Report: TAB Report
Function: Test, Adjust, & Balance
Date: 09/03/2025
Completed By: National TAB

PROJECT
09-01-25 WAWA #7401 PLAINFIELD, IN

Project: 09-01-25 WAWA #7401 PLAINFIELD, IN

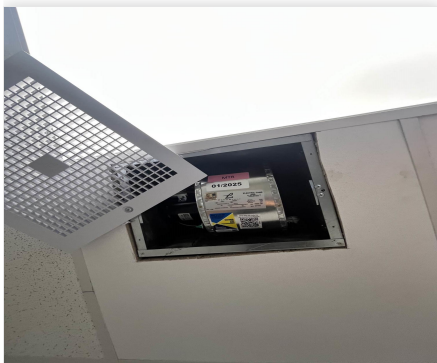
Issue Name : EF-1/EF-2/EF-3 missing speed controllers
Description : EF-1/EF-2/EF-3 missing speed controllers. EF-1/EF-2 are low on flow at EF-1: 312/375CFM EF-2: 226/400CFM Unable to increase due to direct wiring. EF-3 is high on flow at 329/200CFM. Unable to decrease due to direct wiring. Recommend installing speed controllers to properly balance to design airflow.
Created By : National TAB **Assigned To :** National TAB - Dylan Crisman
Status : Open
Priority : Urgent **Asset Tag :**
Originated Date : 09/03/2025 - Dylan Crisman - National TAB

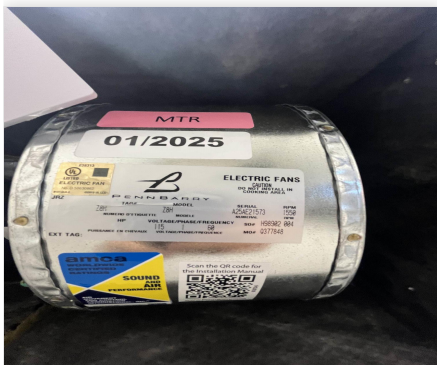
Issue Name : EF-1/EF-2/EF-3 wrong fans installed
Description : Fans per plans show Greenheck fans to be installed. Fans installed on site are PennBarry exhaust fans. Could not confirm with GC/Construction group on if this was an approved change.
Created By : National TAB **Assigned To :** National TAB - Brianna Biggs
Status : Open
Priority : InfoOnly **Asset Tag :**
Originated Date : 09/03/2025 - Dylan Crisman - National TAB

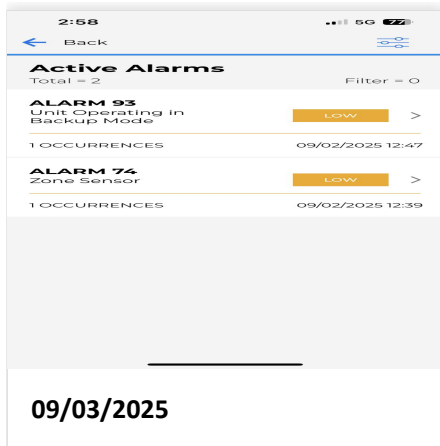
Issue Name : RTU-1/RTU-2/RTU-3 missing space sensors
Description : Missing space sensors and wiring for sensors to RTUs. Wires will need to be ran and sensors installed in proper places per plans on MSET. Units are operating on return air back up currently due to this and shows an alarm for space sensors.
Created By : National TAB **Assigned To :** National TAB - Dylan Crisman
Status : Open
Priority : Urgent **Asset Tag :**
Originated Date : 09/03/2025 - Dylan Crisman - National TAB

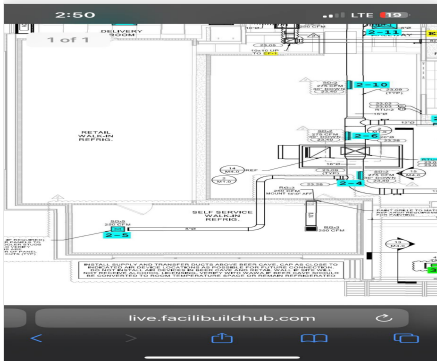
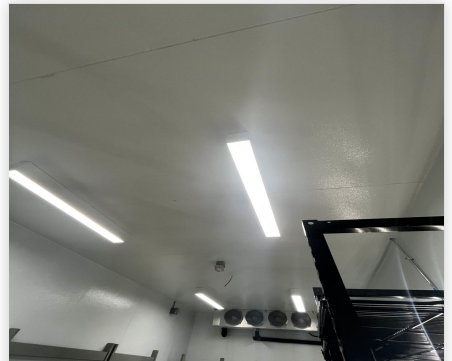
Issue Name : RTU-2 diffuser 2-5 Deleted
Description : RTU-2 diffuser 2-5 to walk in cooler has been deleted per GC/Construction group, Duct has been added for future considerations but confirmed that the diffuser has been deleted and damper for duct has been fully closed. Balanced rest of units diffusers to design.
Created By : National TAB **Assigned To :** National TAB - Dylan Crisman
Status : Open
Priority : InfoOnly **Asset Tag :**
Originated Date : 09/03/2025 - Dylan Crisman - National TAB

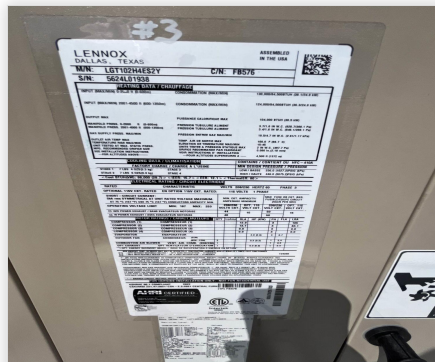
Issue Name : RTU-2 Spiral duct Diffusers
Description : Spiral duct diffusers in open sales floor are unable to be balanced due to having the incorrect damper type installed. They have a deflector plate that only covers half of the free area of the diffuser grille. When fully closed it doesn't lower CFM value, rather pushes all air to one side of the register. OBD dampers are to be installed per spec.
Created By : National TAB **Assigned To :** National TAB - Dylan Crisman
Status : Open
Priority : Urgent **Asset Tag :**
Originated Date : 09/04/2025 - Dylan Crisman - National TAB

Asset: RTU1

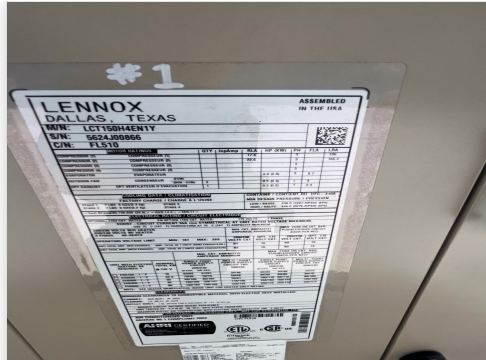
Notes:
Unable to balance spiral duct diffusers due to deflector plates being installed instead of OBD integral dampers. Issue Created.
